RE: Colville Tribe Comments on the Draft Supplemental Environmental Impact Statement (SEIS) for the Key Mill Tailings Storage Facility – Filtered Tailings Stack Height Raise (Publication 26-06-014)

**Comments on the Draft Supplemental Environmental Impact Statement (DSEIS) for the
Key Mill Tailings Storage Facility - Filtered Tailings Stack Height Raise**

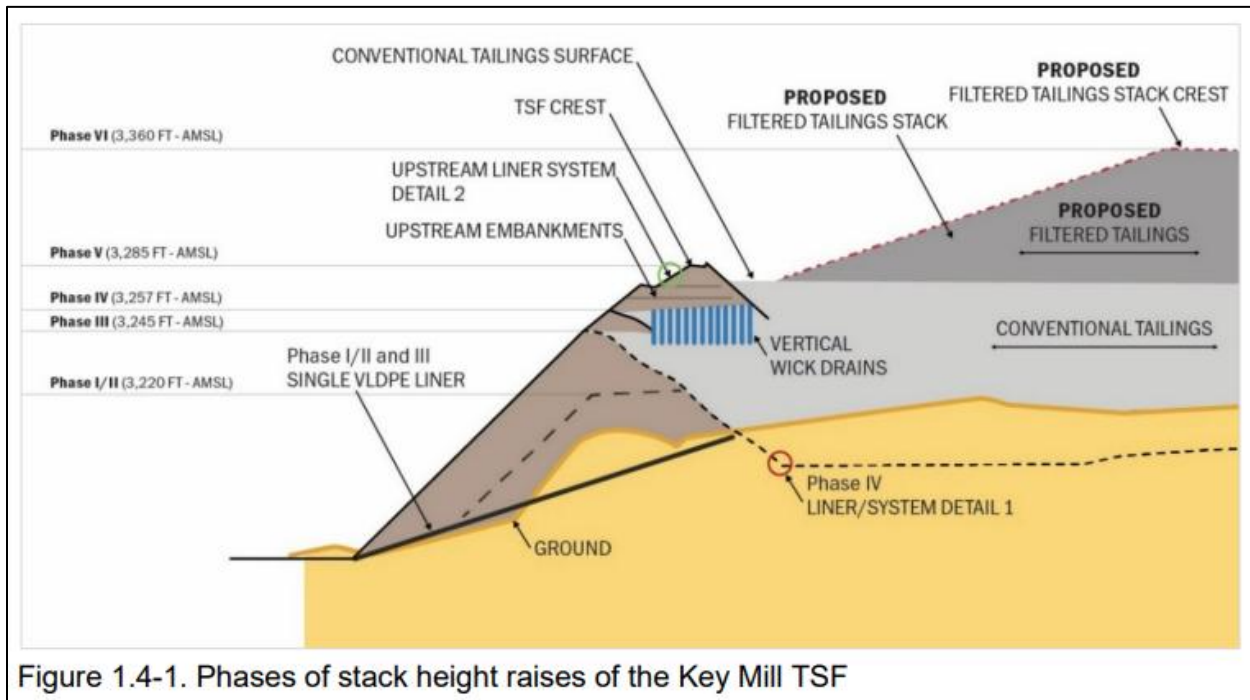
The filtered tailings storage facility would be constructed on top of an existing tailings storage facility that was constructed using the upstream method (see Figs. 1a-b, 2) with the excessively steep slope of 1V:2H (1 meter vertical for two meters horizontal) (see Fig. 3). The upstream construction method was known to be unsafe even three decades prior to the use of the method at the Key Mill Tailings Storage Facility. The construction of outer embankments with such excessively steep slopes was known to be unsafe at the time of construction of these embankments at the Key Mill Tailings Storage Facility.

I am reviewing the meaning and the known danger of the upstream construction method in some detail here, since this background is entirely missing in the DSEIS. Following the review of the upstream construction method, I will also review industry standards and regulations for embankment slopes, since this background is equally entirely missing in the DSEIS.
